JLRTB02004NAS1 TECHNICAL BULLETIN 05 SEP 2019

413-01

Temperature Displayed Incorrectly

| MODEL: | MODEL YEAR: | VIN: | ASSEMBLY PLANT: |
|---------------|--------------|----------------|-----------------|
| E-PACE (X540) | 2019 Onwards | Z15142 Onwards | Graz (Austria) |

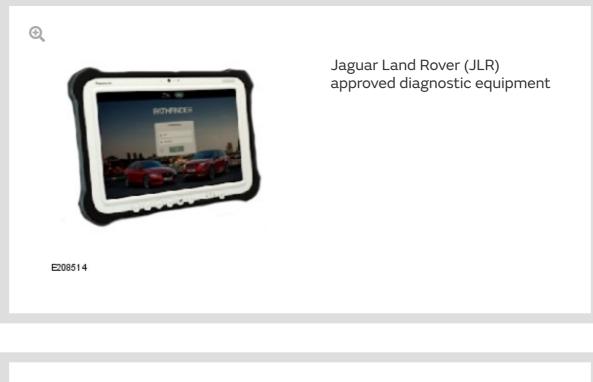
The Ambient Air Temperature (AAT) displayed on the IC is displayed in °C, instead of °F as required.
